Proj. No.: RA 140 DESIGN, BUILD, COMPLETE AND MAINTAIN SHEIKH JABER AL-AHMAD AL-SABAH CAUSEWAY PROJECT (MAIN LINK)	Employer: STATE OF KUWAIT MINISTRY OF PUBLIC WORKS	Request No. RA140-HDC-22-CBR- DRW-0069-01
Engineer's Representative:  dar al-handasah TYLIN INTERNATIONAL	Contractor:  HYUNDAI ENGINEERING & CONSTRUCTION CO., LTD.	Date 20/02/2016

Transmittal of Design Drawing

Detailed Design - Main Bridge Steel Cross Beam Drawing Package

TRS-1739 Main Bridge - Steel Cross Beam

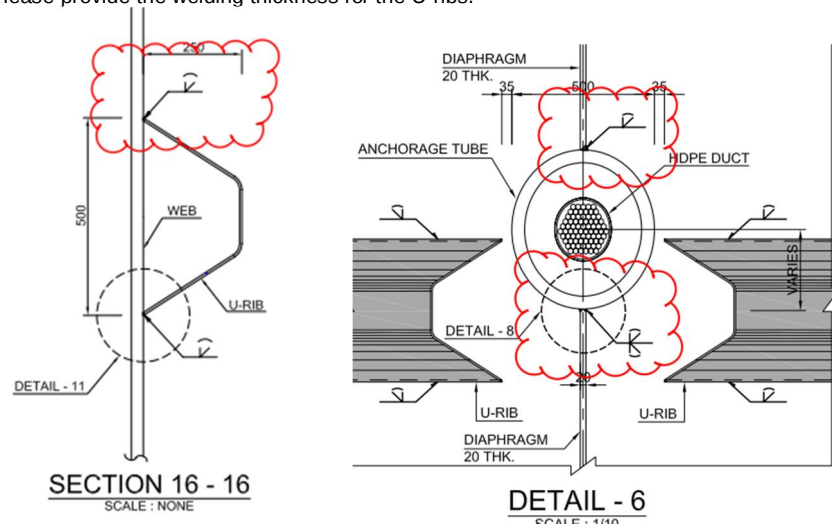
No.	Rev.	Reference	Comment rev.	Comment or Non-Conformance	Response	Cat. ¹
3	A1	DW-34492	1 st	In the section 16-16, the direction of welding is wrong. Please clarify. Please provide the welding thickness for the U-ribs.  SECTION 16 - 16 SCALE : NONE DETAIL - 6 SCALE : 1/10 In the Detail-6, welding method between anchorage tube and diaphragm is difference at the both anchorage tube, Please clarify.	In the section 16-16 and Detail-6, welding marking was revised as follows.  SECTION 16 - 16 SCALE : NONE DETAIL - 6 SCALE : 1/10	2
A2			2 nd	No further comments.	Noted.	A

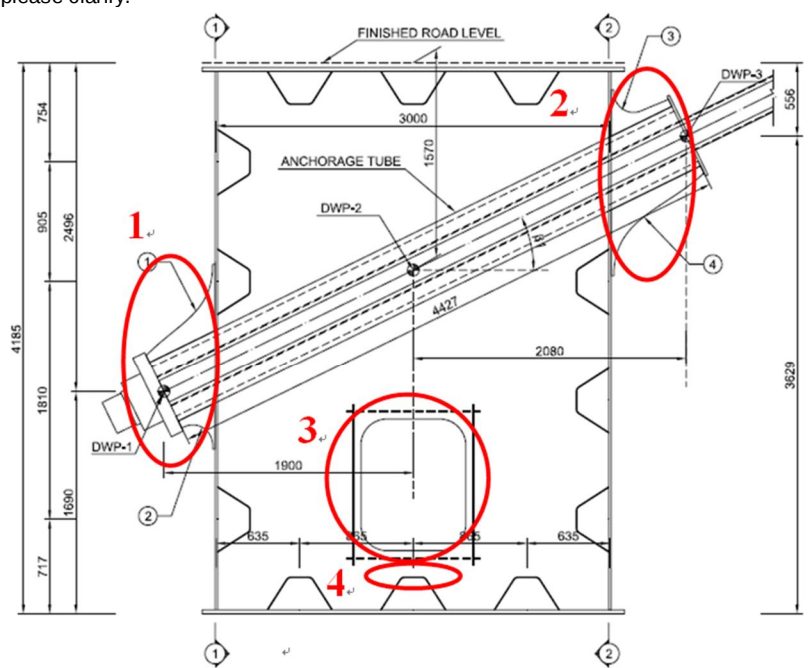
No.	Rev.	Reference	Comment rev.	Comment or Non-Conformance	Response	Cat. ¹
4	A1	Structural resistance of anchorage zone	2 nd	From the FEA(finite element analysis) checking result, Summary of non-conformance of anchorage zone of steel cross beam is depicted in the figure below. Please refer to the noted positions shown in the figure and please clarify.  Position reference		2

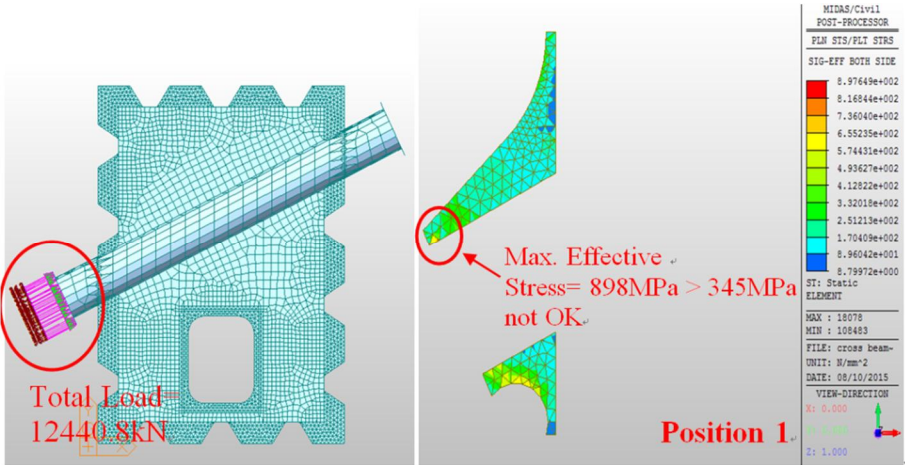
No.	Rev.	Reference	Comment rev.	Comment or Non-Conformance	Response	Cat. ¹
4.1	A2		2 nd	1. A FE model was produced for checking the performance of steel cross beam, with a total load of 12440.8kN applied at the end of cable anchor as shown below (left) (Upper, lower and side plates are not shown). The modeled effective stress distribution of the stiffeners shown below (right) suggests that the stress experienced by the stiffeners exceeds 345MPa. Please clarify.  Max. Effective Stress = 898MPa > 345MPa not OK. Position 1.	Since we don't have the same results, could you please provide much more details about your model so we can compare: - What exactly has been modeled? - What are the boundary conditions? - Are all stiffeners included in your FEM models (including the manhole stiffeners)? Our first remark will be that concentrated stresses on an angle of a triangle element in a FEM model are irrelevant. You can see that while maximum stresses of 898MPa appear on a triangle joint, the average stresses in all elements around are less than 251MPa which is acceptable. For the bottom stiffener, the radius doesn't seem to be constant as it is on the drawing.	2

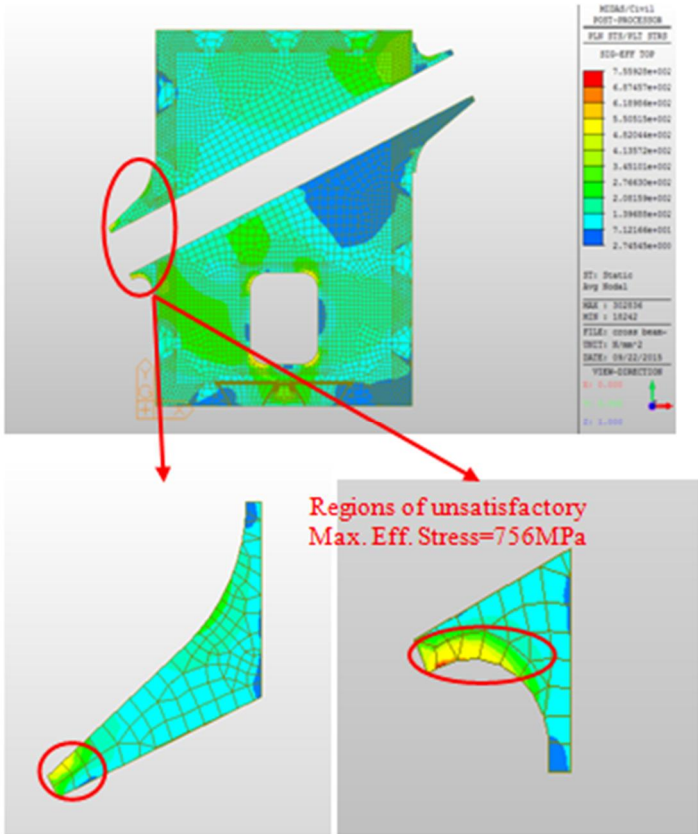
No.	Rev.	Reference	Comment rev.	Comment or Non-Conformance	Response	Cat. ¹
4.1			3 rd	 Regions of unsatisfactory Max. Eff. Stress=756MPa	The results of the analysis in extreme limit state indicate that the Von Mises stress in cross beam diaphragm is generally less than 256 MPa, which is the material strength applied with resistance factor. The stress in stiffener in anchorage zone exceeds the material strength although the shape of the stiffener was changed (enlarged) to reduce the stress. The stress is however very local, thus it is thought the value could be negligible. Because : - Even if this area is plasticized, there will be no loss of structural integrity. - Also, the redistributed stress in the around area will still be within allowable stress. 	2

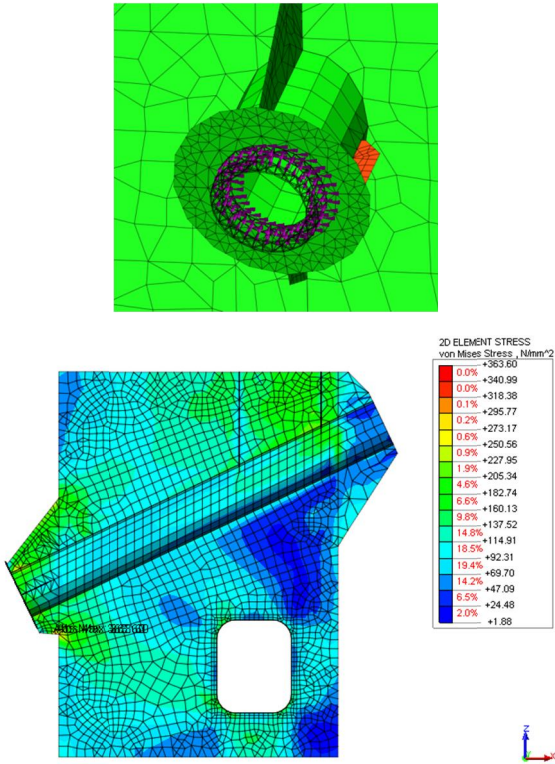
Please specify the input cable force of your model. In the revised model presented below, the same cable load of 12441.7kN is used.

ICE recommends that additional stiffeners install to anchorage zone for considering of the construction error of anchorage install.

Noted.
The cable force of 12562kN was applied with lateral load of 2.5% of the cable force and the additional stiffeners were installed in anchorage zone as per ICE comment as shown in figure below.

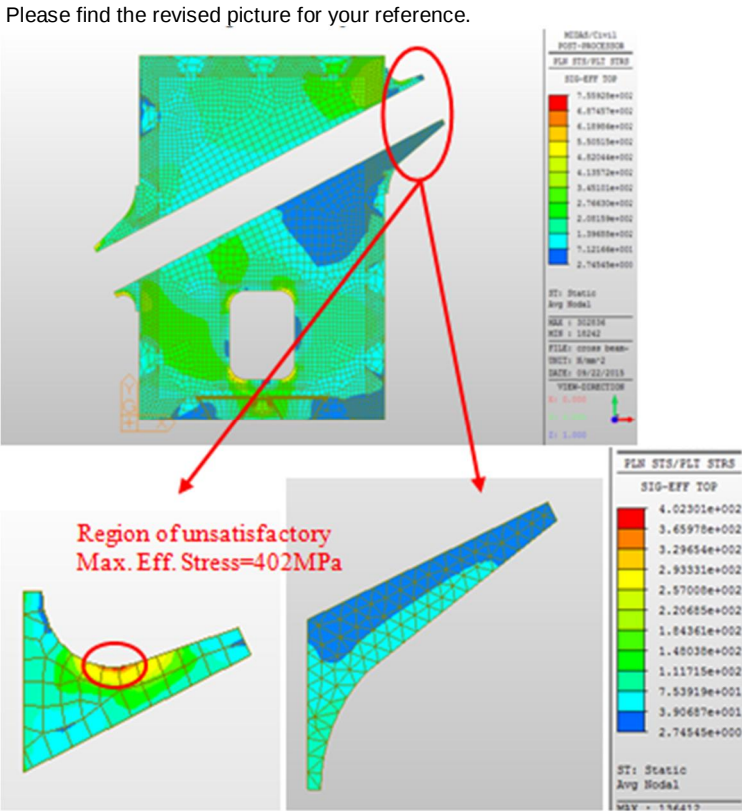
4.2	A2	3 rd	Please find the revised picture for your reference.  The maximal stress of 208 MPa was observed at top right corner as figure below, which is less than material strength applied with resistance factor. 	2
-----	----	-----------------	---	---

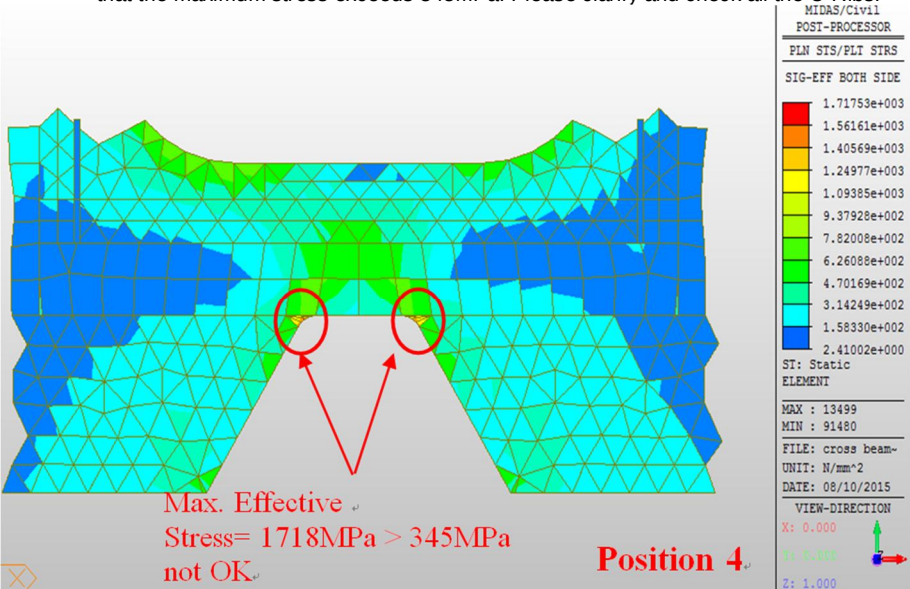
4.4	A2	2 nd	4. The modeled effective stress distribution of the diaphragm near U-Ribs shown below suggests that the maximum stress exceeds 345MPa. Please clarify and check all the U-Ribs.  Max. Effective Stress= 1718MPa > 345MPa not OK Position 4	In FEM modelling, triangle meshing is to be avoided as much as possible, and it's considered that the proportions between two sides of an element should never exceed a factor 2 (meaning one side of a triangle should be no more than two times the length of another side). The problematic elements are made of three nearly flat triangles. To be able to compare our results and see if plate thicknesses increase are necessary, could you please show us the results when you exclude those elements so we can see the average stresses in the diaphragm between the U-rib stiffener and the manhole?	2
-----	----	-----------------	---	---	---

- Steel cross beam Section E'-E' (SCB-1)

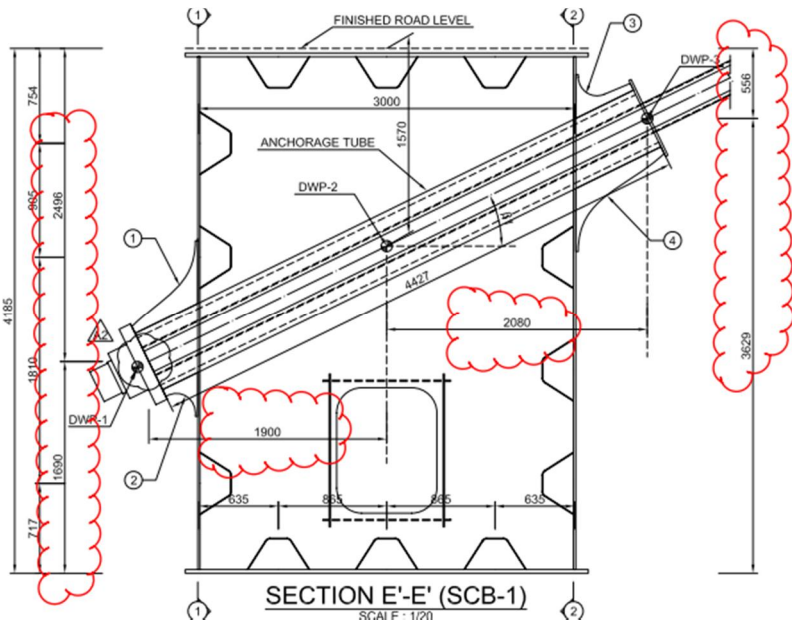
5	A2	DW-34485~34491	3 rd	There are different dimensions of anchorage details between coordinates table (DW-34653) and cross-beam section E'-E' drawing. Please clarify. ex) - DW-34653 Deck - Stay Cable Coordinates Stay Cable : CW-1 <table><tr><td></td><td>DWP-1</td><td>DWP-2</td><td>(DWP-2)-(DWP-1)</td></tr><tr><td>x</td><td>524.860</td><td>526.850</td><td>1.990</td></tr><tr><td>y</td><td>29.364</td><td>30.296</td><td>0.932</td></tr><tr><td>z</td><td>-1.150</td><td>-1.150</td><td>0.000</td></tr></table> Stay Cable : CW-1 <table><tr><td></td><td>DWP-2</td><td>DWP-3</td><td>(DWP-2)-(DWP-1)</td></tr><tr><td>x</td><td>526.850</td><td>528.573</td><td>1.723</td></tr><tr><td>y</td><td>30.296</td><td>31.103</td><td>0.807</td></tr><tr><td>z</td><td>-1.150</td><td>-1.150</td><td>0.000</td></tr></table> Stay Cable : CW-2 <table><tr><td></td><td>DWP-1</td><td>DWP-2</td><td>(DWP-2)-(DWP-1)</td></tr><tr><td>x</td><td>544.860</td><td>546.850</td><td>1.990</td></tr><tr><td>y</td><td>29.422</td><td>30.359</td><td>0.937</td></tr><tr><td>z</td><td>-1.150</td><td>-1.150</td><td>0.000</td></tr></table> Stay Cable : CW-2 <table><tr><td></td><td>DWP-2</td><td>DWP-3</td><td>(DWP-2)-(DWP-1)</td></tr><tr><td>x</td><td>546.850</td><td>548.840</td><td>1.990</td></tr><tr><td>y</td><td>30.359</td><td>31.297</td><td>0.938</td></tr><tr><td>z</td><td>-1.150</td><td>-1.150</td><td>0.000</td></tr></table> Stay Cable : CW-3 <table><tr><td></td><td>DWP-1</td><td>DWP-2</td><td>(DWP-2)-(DWP-1)</td></tr><tr><td>x</td><td>564.860</td><td>566.850</td><td>1.990</td></tr><tr><td>y</td><td>29.460</td><td>30.403</td><td>0.943</td></tr><tr><td>z</td><td>-1.150</td><td>-1.150</td><td>0.000</td></tr></table> Stay Cable : CW-2 <table><tr><td></td><td>DWP-2</td><td>DWP-3</td><td>(DWP-2)-(DWP-1)</td></tr><tr><td>x</td><td>566.850</td><td>568.836</td><td>1.986</td></tr><tr><td>y</td><td>30.403</td><td>31.344</td><td>0.941</td></tr><tr><td>z</td><td>-1.150</td><td>-1.150</td><td>0.000</td></tr></table>		DWP-1	DWP-2	(DWP-2)-(DWP-1)	x	524.860	526.850	1.990	y	29.364	30.296	0.932	z	-1.150	-1.150	0.000		DWP-2	DWP-3	(DWP-2)-(DWP-1)	x	526.850	528.573	1.723	y	30.296	31.103	0.807	z	-1.150	-1.150	0.000		DWP-1	DWP-2	(DWP-2)-(DWP-1)	x	544.860	546.850	1.990	y	29.422	30.359	0.937	z	-1.150	-1.150	0.000		DWP-2	DWP-3	(DWP-2)-(DWP-1)	x	546.850	548.840	1.990	y	30.359	31.297	0.938	z	-1.150	-1.150	0.000		DWP-1	DWP-2	(DWP-2)-(DWP-1)	x	564.860	566.850	1.990	y	29.460	30.403	0.943	z	-1.150	-1.150	0.000		DWP-2	DWP-3	(DWP-2)-(DWP-1)	x	566.850	568.836	1.986	y	30.403	31.344	0.941	z	-1.150	-1.150	0.000	The coordinates table in DW-34653 is correct. The table in the crossbeam drawing package will be corrected in revision.	2

4th No further comments.
